Unit D North Bank Road, Port Talbot

Transport Note

Document Reference: **C24120/TN01**

- 1.1.1 Apex Transport Planning (“Apex TP”) has prepared this Transport Note (TN) to provide further information in response to comments provided by the highway authority, Neath Port Talbot County Borough Council (NPTCBC), in relation to the planning application (reference: P2024/0212). The application is for the construction of industrial unit comprising 4 no. self-contained units, with unit 1-2 operating as a class 7 MOT centre for vans and cars, and units 3-5 for B2 or B8 use class, on land off North Bank Road, Port Talbot, SA13 1RE.

C24120-ATP-DR-TP-0001

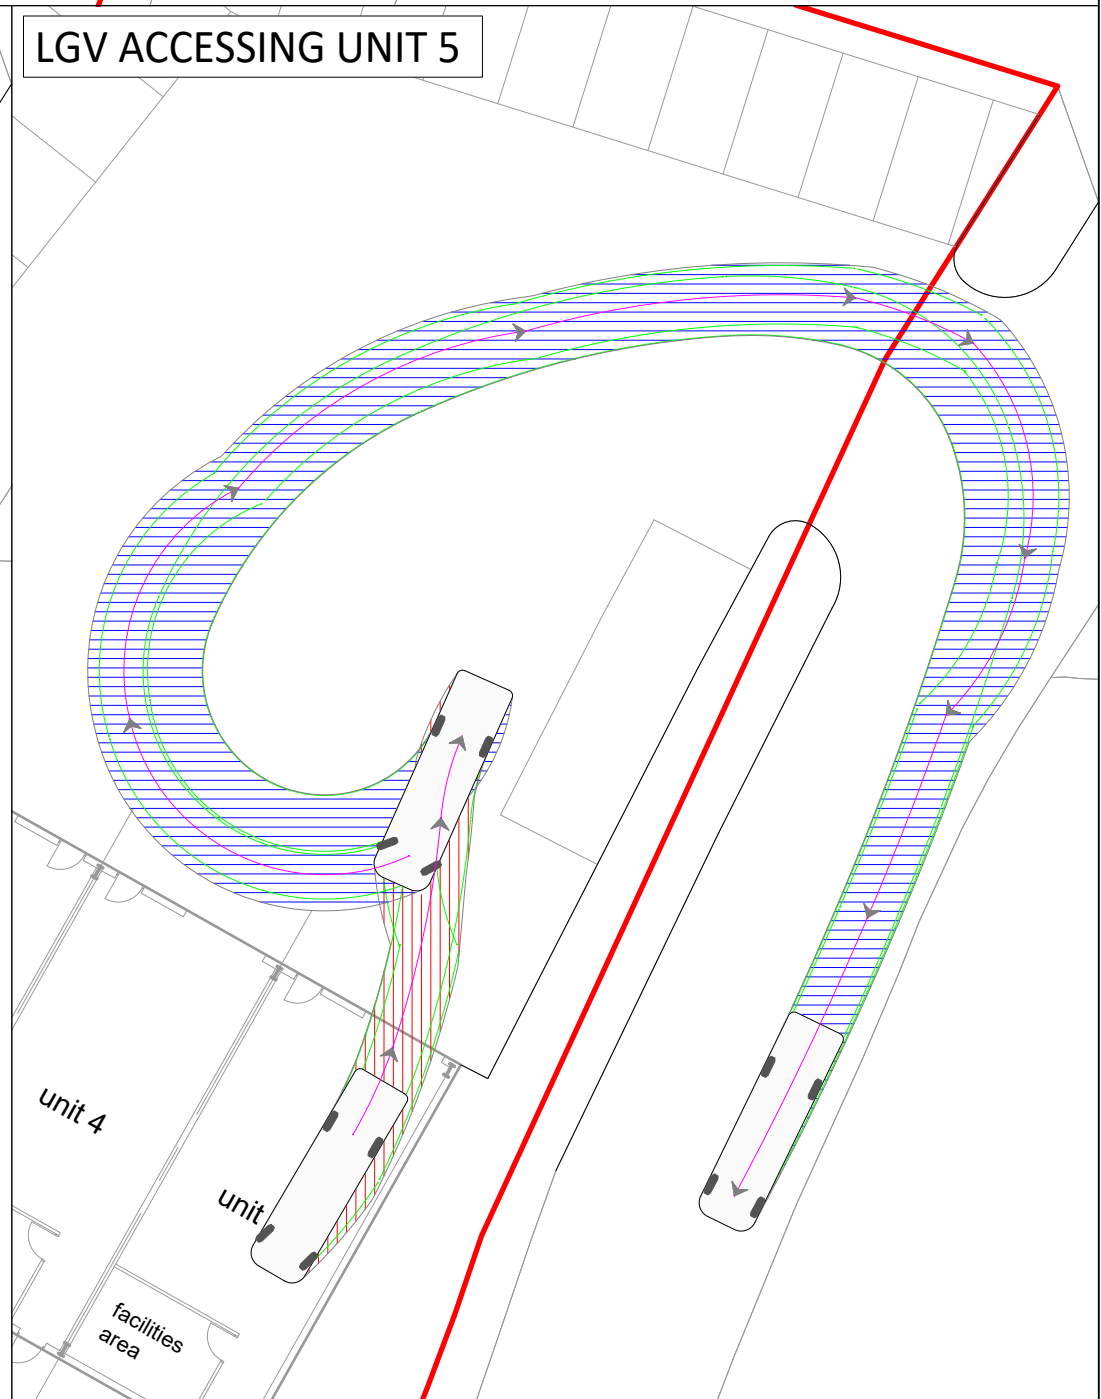
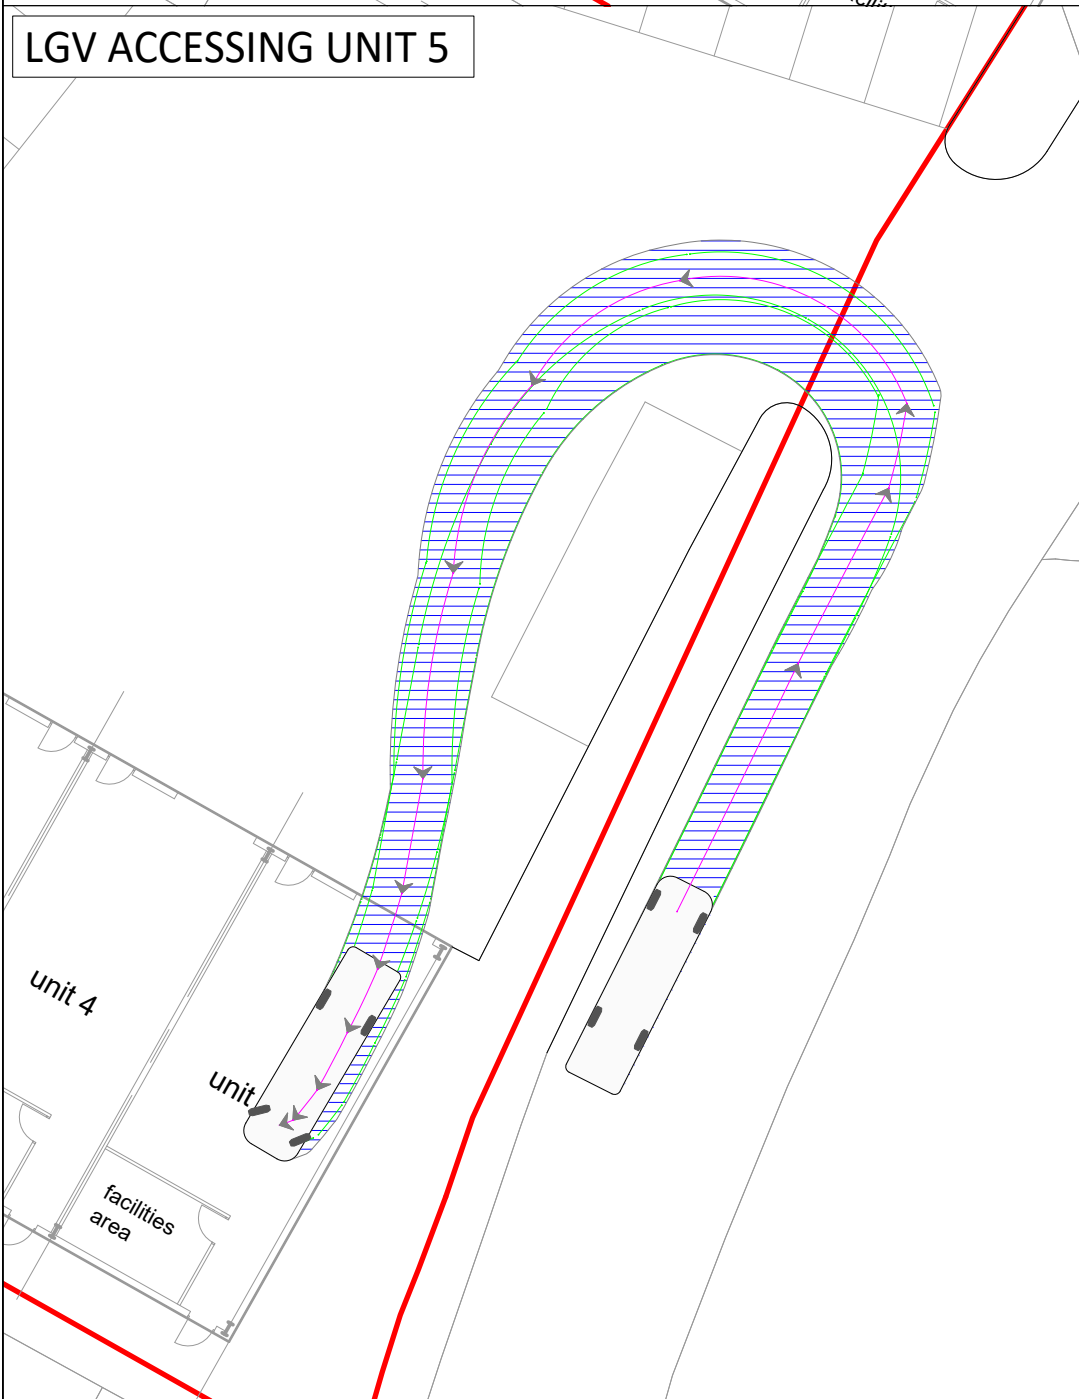
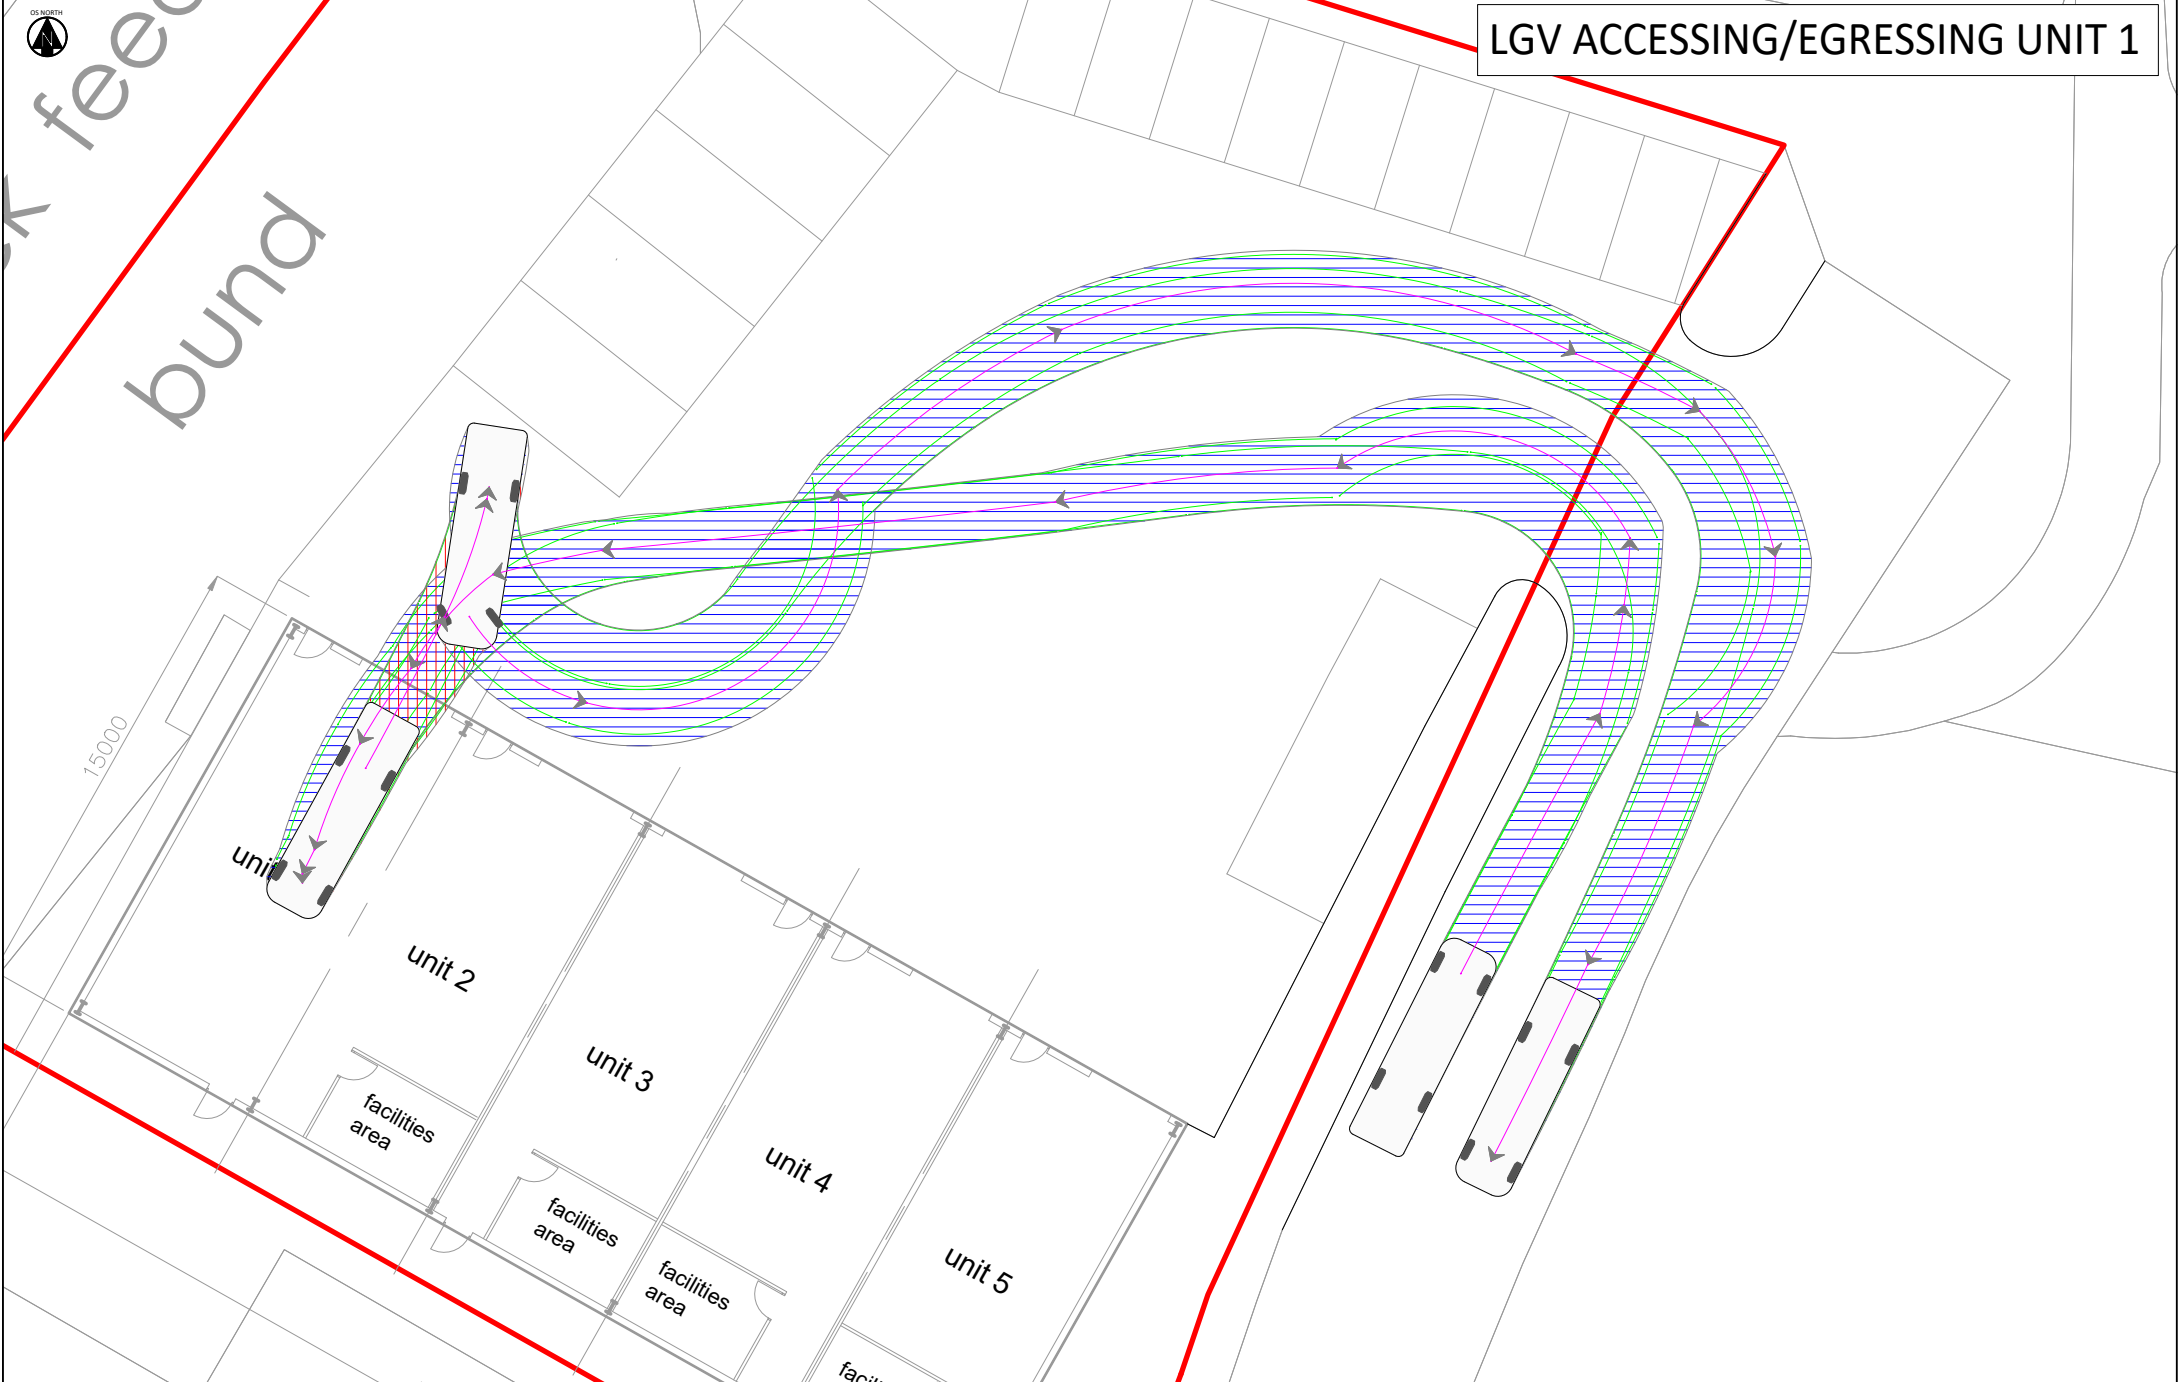
“Vision splays should be annotated on a suitably scaled drawing in accordance with TAN 18. It appears the vision splays have been drawn in accordance with Manual for Streets which only applies to streets.”

- 2.1.1 TAN 18 has been used to calculate the required visibility splays at the access. The document states that the visibility requirements in ‘Table B is designed for roads in built up areas where actual or design speeds are 60km/h or below (not applicable to trunk roads). Figures in Table B may be interpolated from this table or calculated as in Manual for Streets’.

- 2.1.2 North Bank Road is subject to a 20mph speed limit and therefore visibility splays of 2.4m x 25m, in line with Manual for Streets (MfS) and TAN 18, have been provided on drawing C24120-ATP-DR-TP-0001 (attached at Appendix C). This drawing demonstrates that the required visibility can be achieved at the proposed access.

- 2.1.3 To the north of the access the visibility is provided to the end of the unadopted road, as this is a cul-de-sac. Given vehicles would not be approaching from this direction, unless turning slowly, this is appropriate and safe and good visibility is also provided to the shared footway / cycleway route.
